SERVICE BULLETIN

TITLE: LANDING GEAR - NOSE LANDING GEAR FORWARD RETRACT PLUNGER ROD INSPECTION / REPLACEMENT

Figure 1

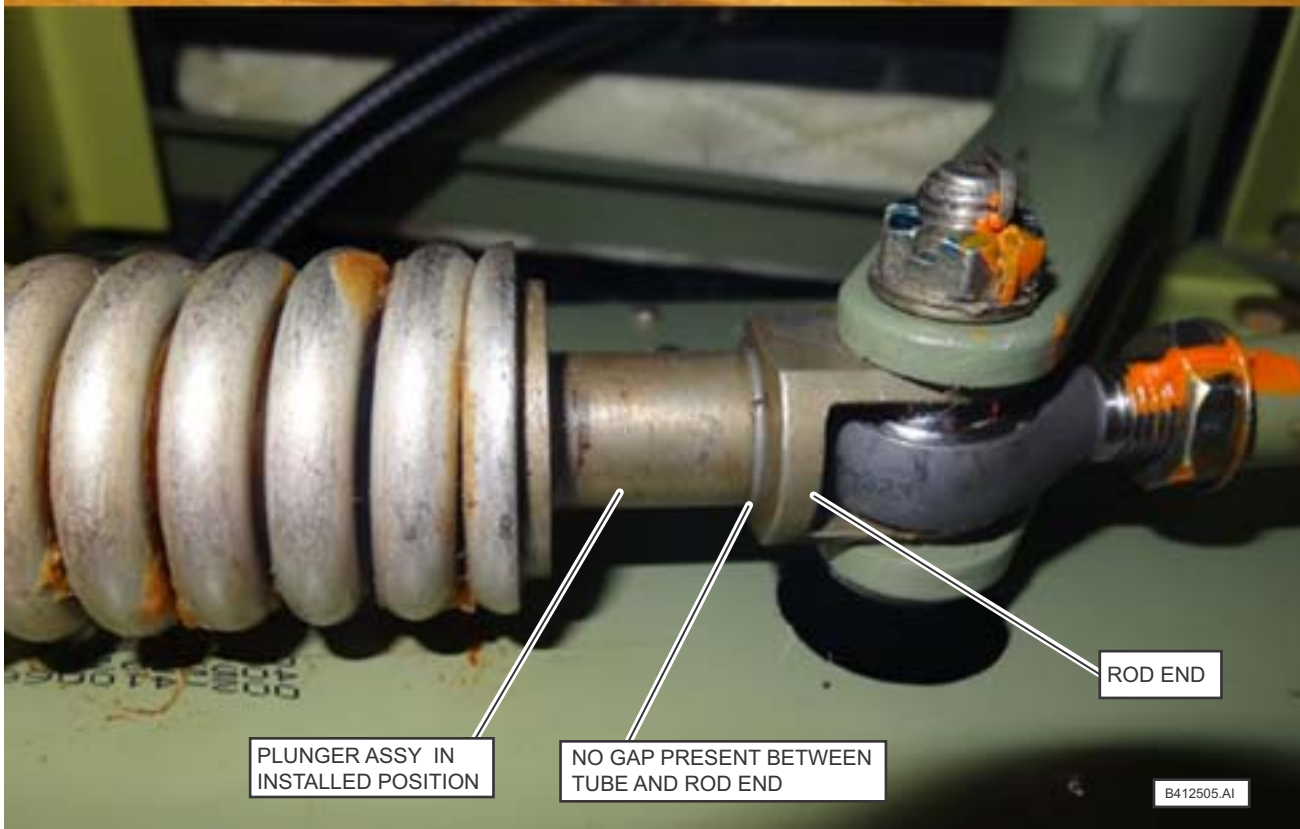
- (3) Inspect the P/N 35-825094-4 NLG plunger assembly rod end at the intersection with the plunger tube and rod end in accordance with the following:
 - (a) For Bonanza models - Refer to Figure 4 for access points for the P/N 35-825094-4 NLG plunger assembly. Inspect for a braze (fillet) between the plunger tube and the rod end. Refer to Figure 1. Lack of a braze will be indicated by a recessed gap. If no braze is present, proceed to Step (4) to remove and replace the P/N 35-825094-4 NLG plunger assembly with a properly brazed P/N 35-825094-4 NLG plunger assembly. If a braze fillet is present, proceed to Step (16).

Figure 2

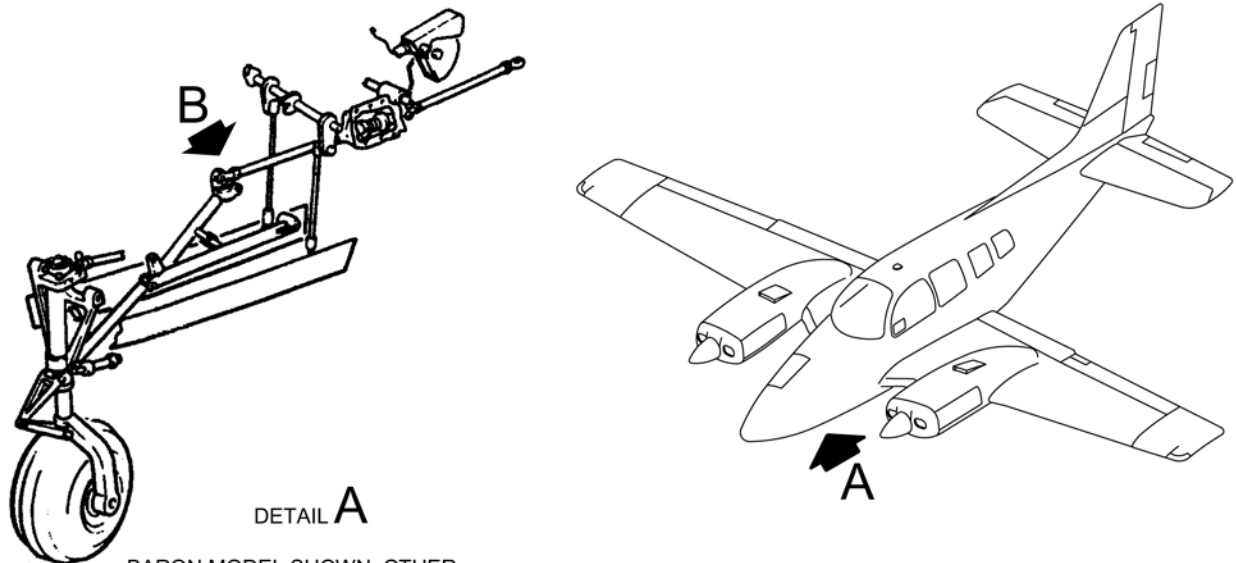
- (b) For Baron models - Refer to Figure 5 and remove access panel 15 by removing and retaining attachment screws. Retain the access panel and attachment screws for reinstallation following inspection/replacement. Inspect for a braze (fillet) between the plunger tube and the rod end. Refer to Figure 2. Lack of a braze will be indicated by a recessed gap. If no braze is present, proceed to Step (4) to remove and replace the P/N 35-825094-4 NLG plunger assembly with a properly brazed P/N 35-825094-4 NLG plunger assembly. If a braze fillet is present, proceed to Step (16).

Location of NLG Plunger Assembly
Figure 3

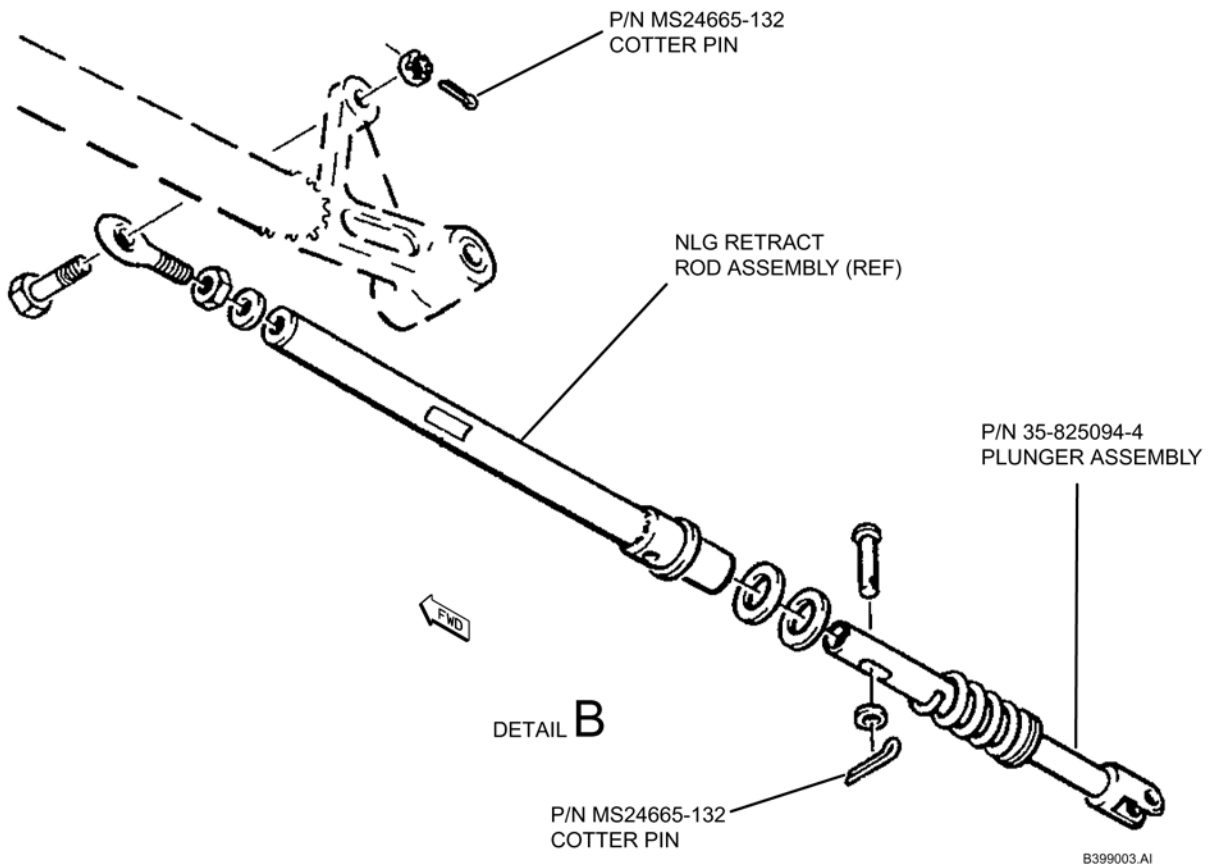
- (8) Remove NLG retract rod assembly. Discard cotter pins but retain other hardware. Refer to Figure 3.

- (11) Replace ONLY the P/N 35-825094-4 plunger assembly using hardware retained from Step (9) and new cotter pin, P/N MS24665-132. Refer to applicable MM Chapter 32-00-00, Figure 3, and Figure 4 (Bonanza) or Figure 5 (Baron).

Figure 4

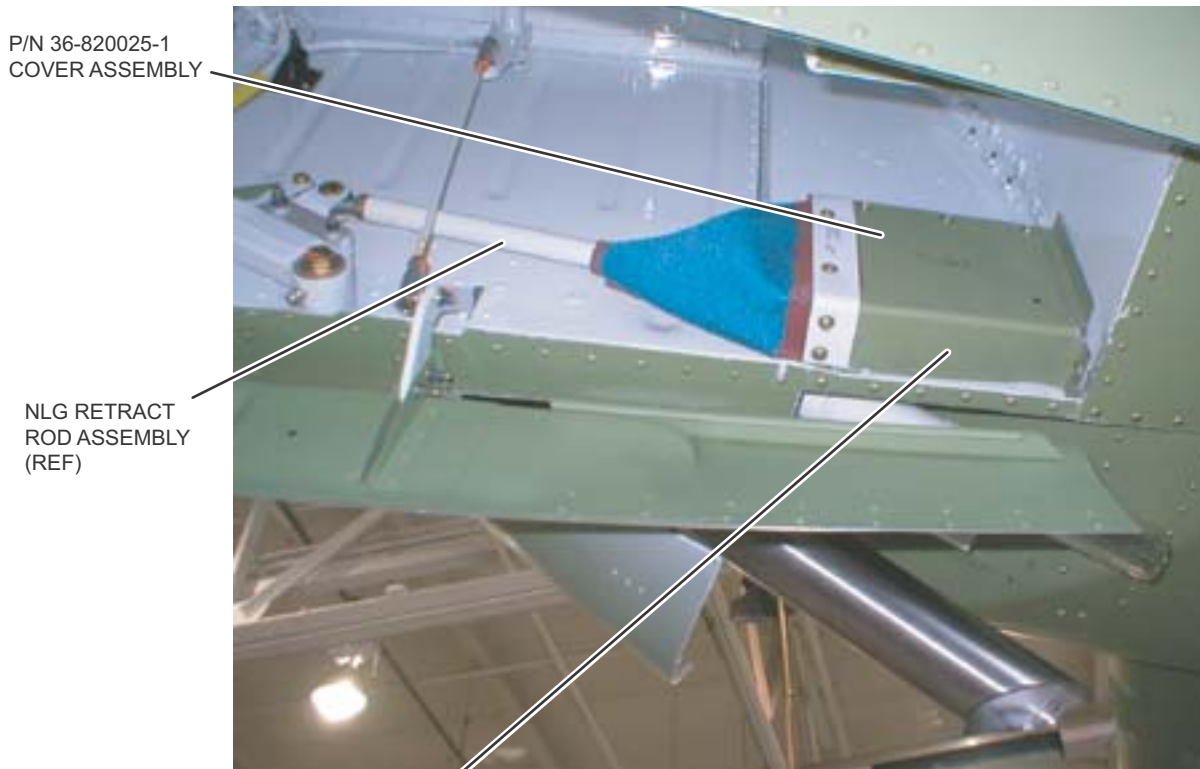
- G58 Baron: Perform: *ELECTRICAL POWER - DISCONNECT*. Refer to MMS Chapter 24-35-00;
 - 58 Baron: Disconnect batteries. Refer to MM Chapter 24-30-00.
- (7) Gain access to NLG plunger assembly through nose wheel well (Bonanza and Baron) and by removing floorboards, if necessary, under the copilot's rudder pedals (Baron only). Refer to Figures 4 and 5.
